UN#09-106

Subject: UniStar Nuclear Energy, NRC Docket No. 52-016
Calvert Cliffs Nuclear Power Plant, Unit 3
Supplemental Response for RAI HS-13

**Supplemental Response for RAI HS-13
CCNPP Unit 3 Environmental Report**

Figure 4.2-1—(Final Site Grading Plan CCNPP Unit 3)

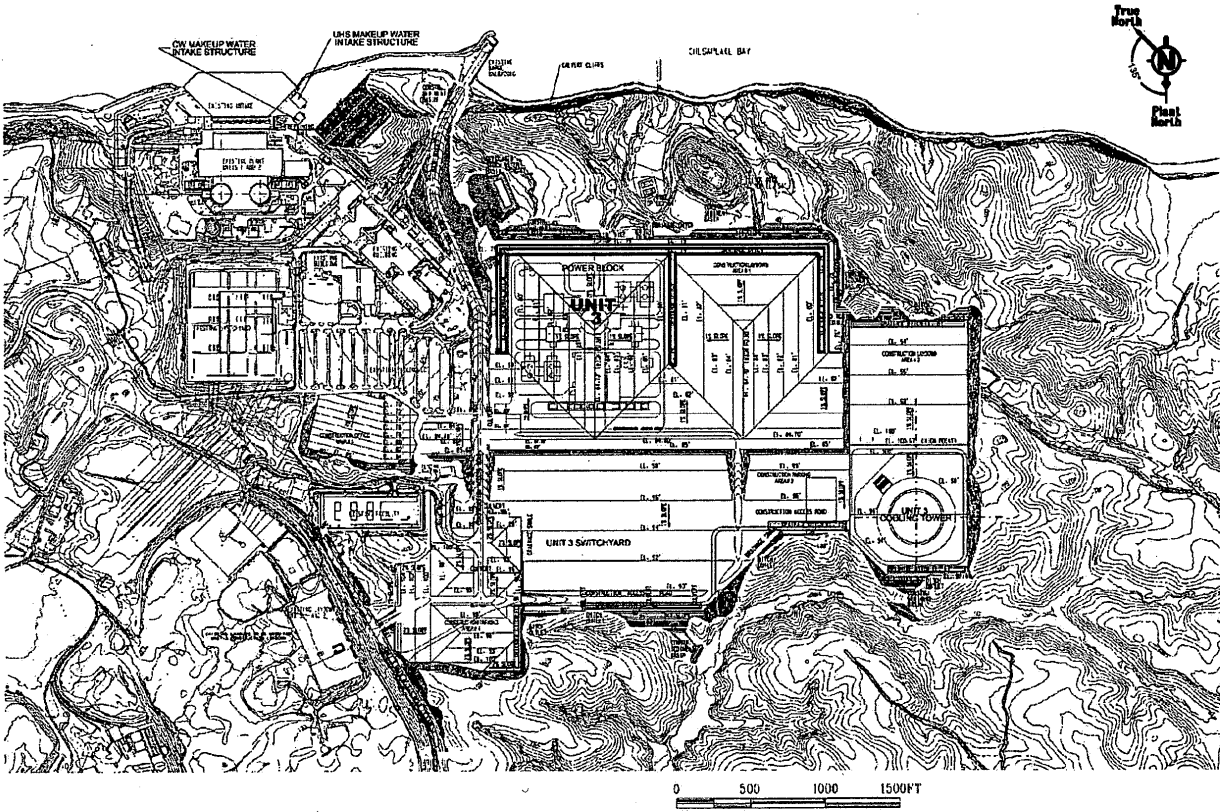
A permanent groundwater dewatering system is not anticipated to be a design feature for the CCNPP Unit 3 facilities. Removal of a portion of the Surficial aquifer during construction may eventually lower the expected depth to groundwater. Surface water controls to minimize precipitation infiltration and the redirection of surface runoff away from the facility area are expected, further minimizing water infiltration to the groundwater system beneath the site. Groundwater elevations will continue to be monitored, and any observed deviations in groundwater elevations potentially impacting the current design basis will be accounted for to design a construction dewatering system, as appropriate (Section 2.3.2.2.11 page 2.3-47). Provide if possible a topographic map with an overlay of the construction foot print and with contours that can be easily read. Describe how the recharge to the Surficial aquifer would be impacted in the short term. Long term is presented in Figures 2.3.2-(24-25). Identify how the seeps and streams would be impacted and how this would impact local wells.

The numerical model of the Surficial aquifer has been revised to evaluate construction impacts to groundwater levels in the vicinity of the power block and stream flow off site in John's Creek. Figure 2.3-86 shows the topography of the post-construction groundwater flow model and Figure 4.2-1 shows the construction footprint of the CCNPP Unit 3 site. Both stream flow and groundwater levels after construction of CCNPP Unit 3 will be dependent upon several factors, including the hydraulic conductivity of the engineered fill material used and the rate of groundwater recharge within the graded area of the site.

The numerical model of the Surficial aquifer has been revised to evaluate construction impacts to groundwater levels in the vicinity of the power block and stream flow off site in John's Creek. Figure 2.3-86 shows the topography of the post-construction groundwater flow model and Figure 4.2-1 shows the construction footprint of the CCNPP Unit 3 site. Both stream flow and groundwater levels after construction of CCNPP Unit 3 will be dependent upon several factors, including the hydraulic conductivity of the engineered fill material used and the rate of groundwater recharge within the graded area of the site.
